INSPECTION REPORT OF 30 MLD STP& IPS FACILITIES AT PANKHA

An Inspection of 30 MLD Pankha STP construction site and associated IPS facilities was jointly conducted by PE and UPJN officials in the presence of KRMPL Representatives, and our findings are noted below.

Dates of Inspection	03/11/2022 & 07/11/2022
Inspection Team	Mr. R. K. Sharma, CE, UPJN, Kanpur Mr. Gyanendra Choudhary, PM-1, UPJN, Kanpur Mr. Rohit Yadav, J.E. Civil, UPJN, Kanpur Dr. Giridhar Prabhukumar, Team Leader, STC Kanpur Mr. Satish Kamaraju, Sr. Process Engineer & Expert, STC Kanpur Mr. Sunil Bastukar, Sr. Mechanical Engineer & Expert, STC Kanpur Mr. Anil Kumar Seth, Sr. Electrical Engineer & Expert, STC Kanpur Mr. Ajay Kumar Goyal, Support Engineer-Mechanical, STC Kanpur Mr. Priyesh Shukla, Supprot Engineer-Civil, STC Kanpur
KRMPL Personnel	Mr. Shawaz, Mechanical Engineer, KRMPL, Kanpur Mr. Raman Kundu, KRMPL, Kanpur Mr. Soumitra Sen, KRMPL Kanpur Mr. Ansari, KRMPL Kanpur
Location	Pankha, ICI Nallah & Sundar Nagar, Kanpur

Fig 2: Monorail Installation

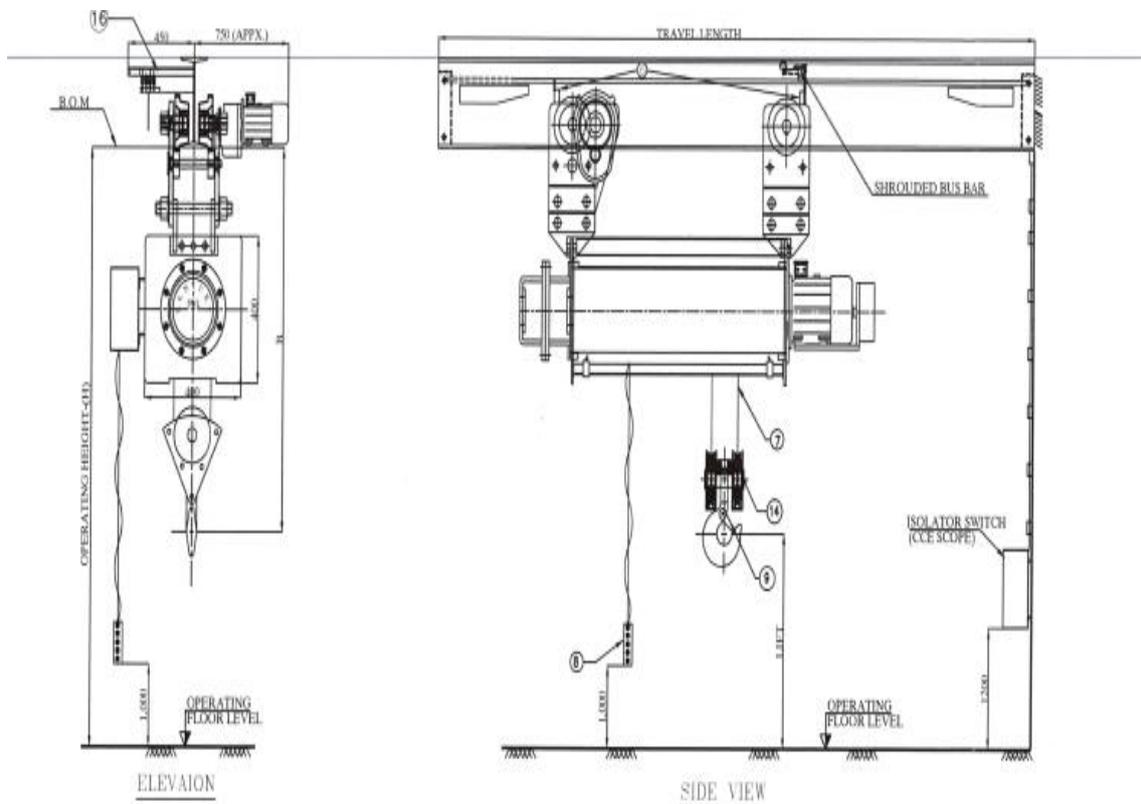
3. Monorail installation work was under progress (Fig 2). Also, its painting work was found pending.
4. Electrical hoist installation is incomplete. It is to be noted, that “shrouded bus bar” has not been installed till date. Both stiffeners should be installed as per approved drawing (Fig 3). Also, trial run of the hoist is required for the electrical hoist as per approved QAP and acceptance certificate of the installation is required from the OEM.

Fig 6: Approved drawing for exhaust chimney & Foundation work for DG set

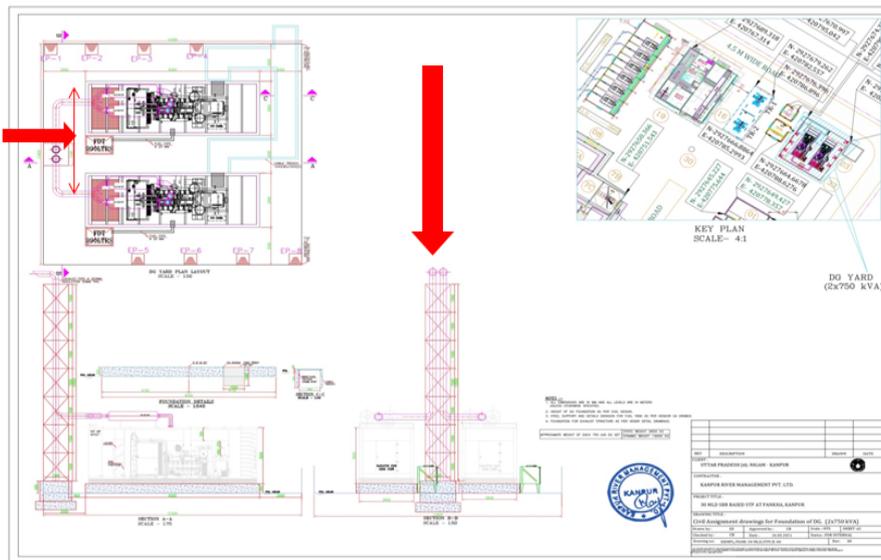
- i. DG isolation panel 1 no. commissioning done
- ii. 2nd DG and isolation panel need to be commissioned.
- iii. Civil foundation & Exhaust chimney installation works are pending for over 1 year. KRMPL has not started the work till date.

Exhaust Chimney & Foundation works Pending at 30 MLD Pankha

Fig 8: Weir Sluice gate (Size 3000X500mm)

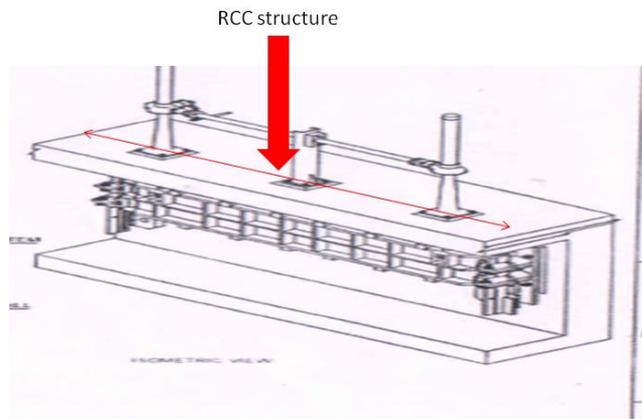
- i. Inlet Weir Sluice Gate (Size 3000mm x 500mm):
 - a. It has not been installed as per approved drawing. It is to be noted that, KRMPL used the structure steel arrangement (Fig: 8) for supporting the connecting pipe support bracket & Pillar of the Sluice Gate. As per approved drawing (Fig 9) RCC structure should be used instead of structure steel arrangement. This indicates the technical negligence from KRMPL's end.
 - b. sluice gate installation & commissioning was not performed in the presence of OEM personnel.
 - c. KRMPL was advised to get the Sluice Gate installation certified by OEM for acceptance.

Fig 13B: Discharge pipeline Blind Flange Installed incorrectly at ICI pump house

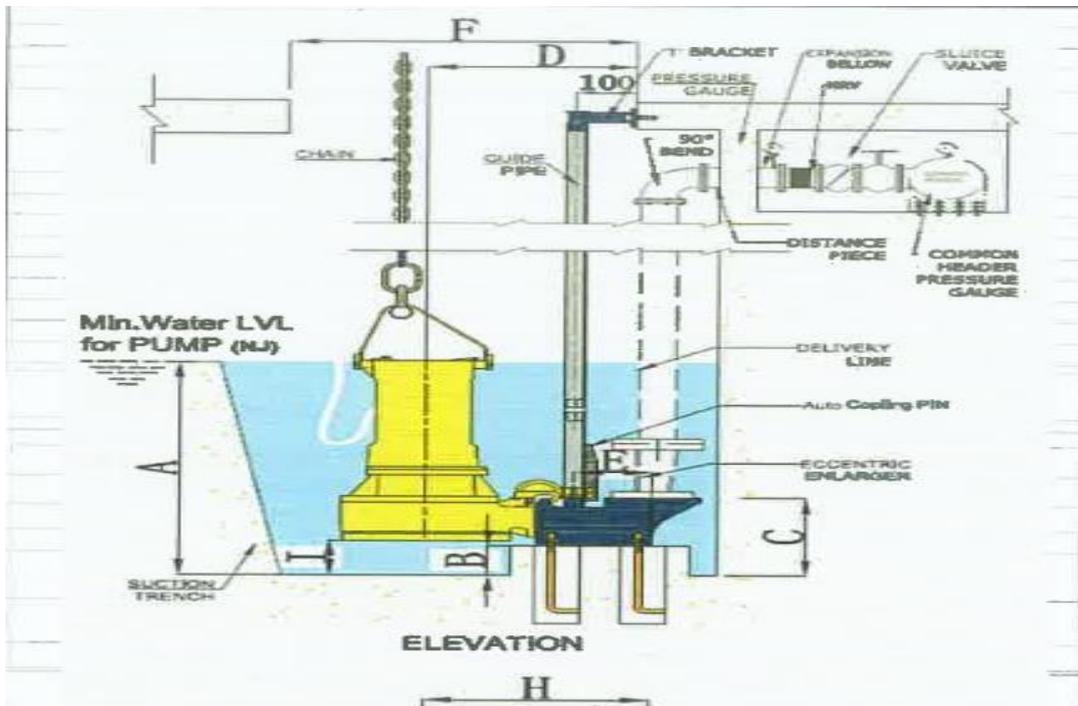
- i. KRMPL is yet to install the following as per approved drawing:
 - a. 5 Nos. Sluice gate valves,
 - b. 5 Nos. NRVs, pressure gauges,
 - c. pipe guide for pump & pipe support
- ii. Blind flange at the end of discharge pipeline was incorrectly installed. It needs to be removed and installed in opposite direction (Fig 13B).
- iii. Block concrete support to be installed in place of the temporary pipe support.
- iv. KRMPL has used unapproved arrangement with temporary spool, wrong size re-used valves (from Jajmau facilities)

KRMPL has taken the sewage without installing the above-mentioned items (5. (i)). Fig. 14 shows all the pump's accessories needed as per approved technical drawing and the same is to be complied by KRMPL.

Fig 16: Approved drawing for Electrical hoist

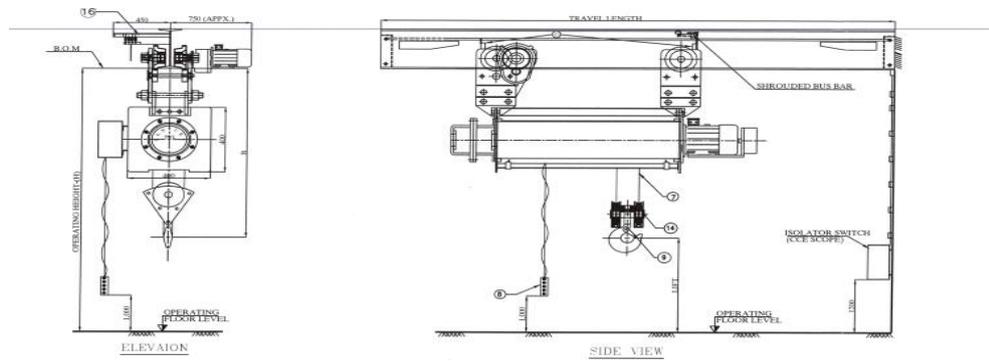
- vi. Electrical hoist installation is incomplete. It is to be noted, that “shrouded bus bar” has not been installed till date. Both stiffeners should be installed as per approved drawing (Fig 16). Also, trial run of the hoist is required for the electrical hoist as per approved QAP (Fig 17)

Fig 24: Receiving chamber

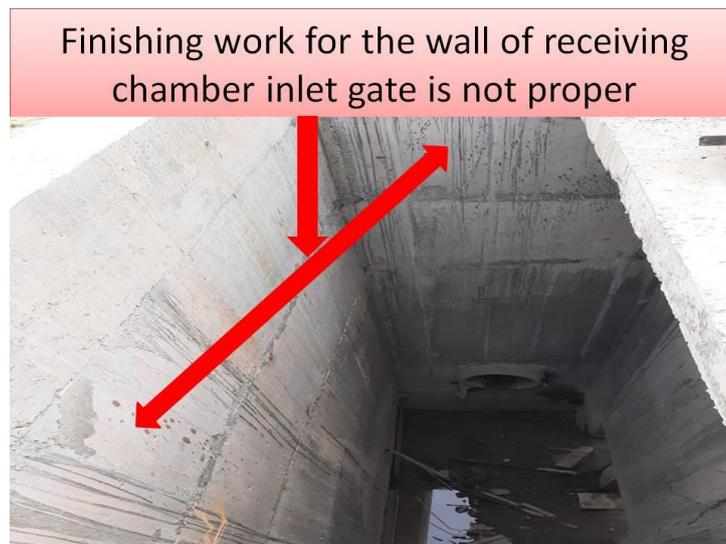
- ii. Walls of receiving chamber inlet gate are not straight and finishing were not proper due to improper shuttering during its concreting work (Fig 24). KRMPL was instructed to do the additional grinding to rectify the defects and coal tar painting in the interiors.
